THE STAR- MODIFICATION 13 LANDSCAPE DESIGN REPORT

PREPARED FOR THE STAR
20.03.2018
REV.B 30.01.19

The Star Modification 13 - Landscape Design

Response to Letter received from Alex Greenwich and the City of Sydney Submission

1 BREATHING WALL SECTION
1:30 @ A3

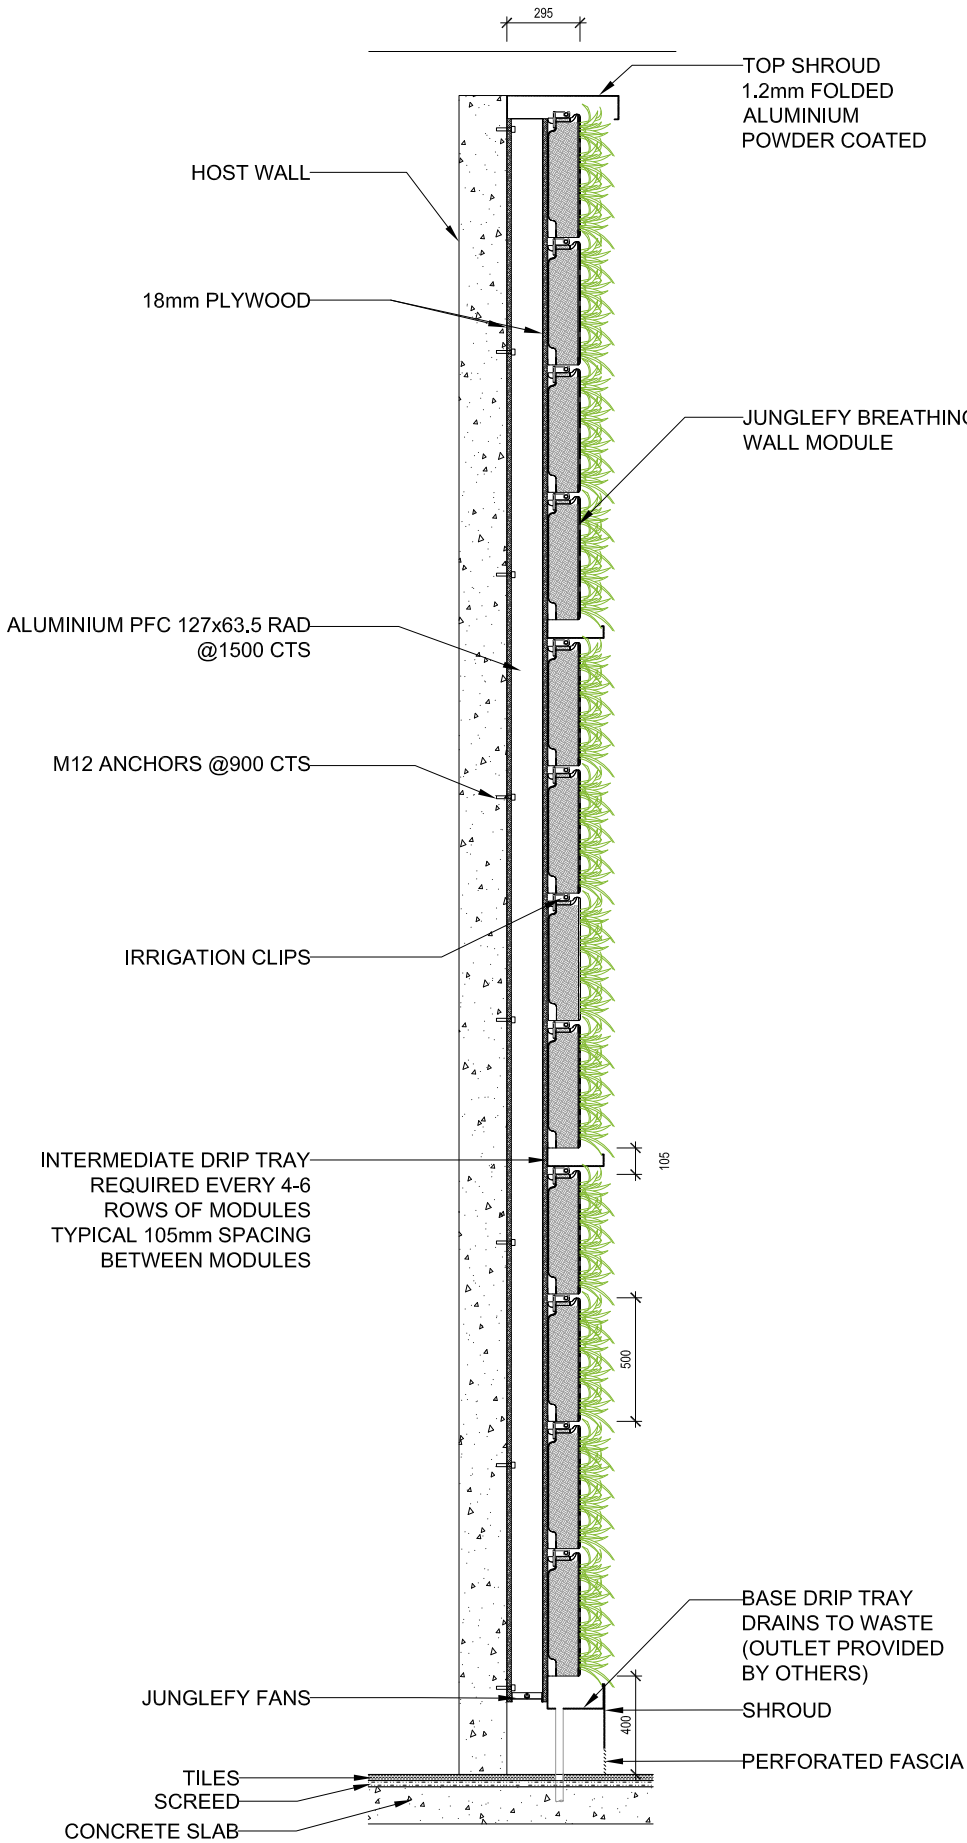
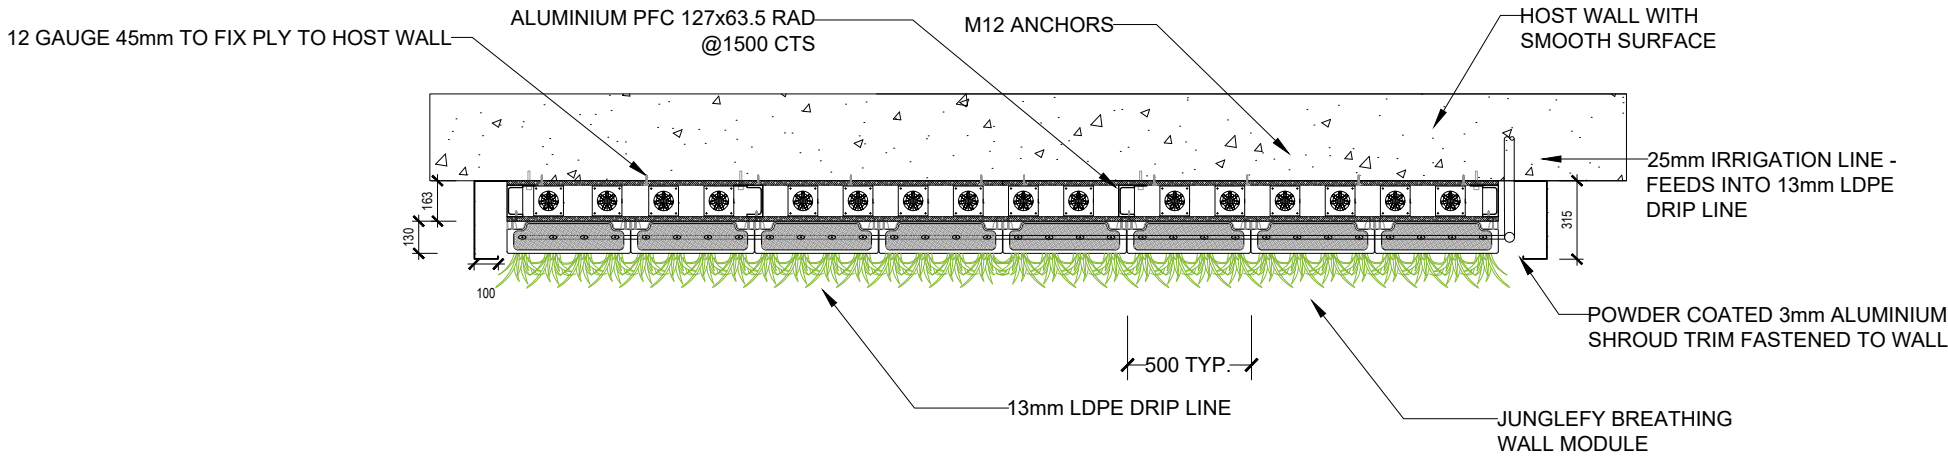
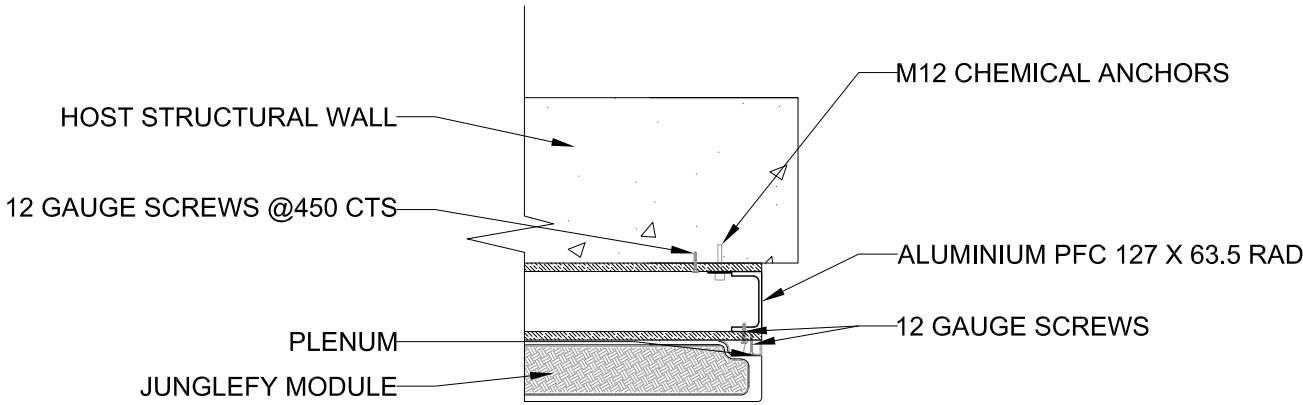
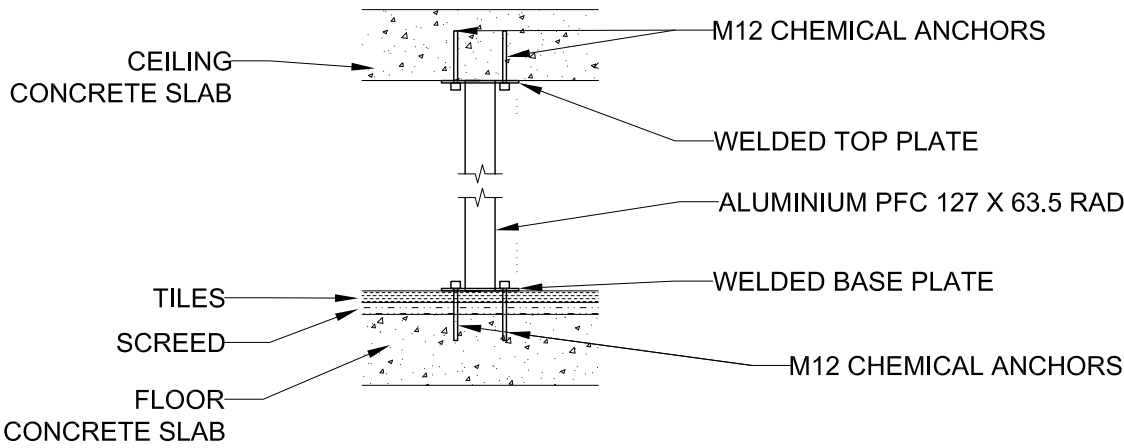
There is a green wall proposed for the Porte Cochere at the entrance to the building. We support the suitability of a green wall in this location on the proviso that it has LED grow lighting installed to ensure successful plant growth. We further propose the installation of a Junglefy Breathing Wall that would use fans to actively filter the exhaust fumes produced from the vehicles in the area, thereby creating a greatly improved air quality for patrons of the hotel. We have provided an indicative detail and specification for the Junglefy Breathing Wall and also provided a list of plant species that would be suitable for this outdoor shaded location.
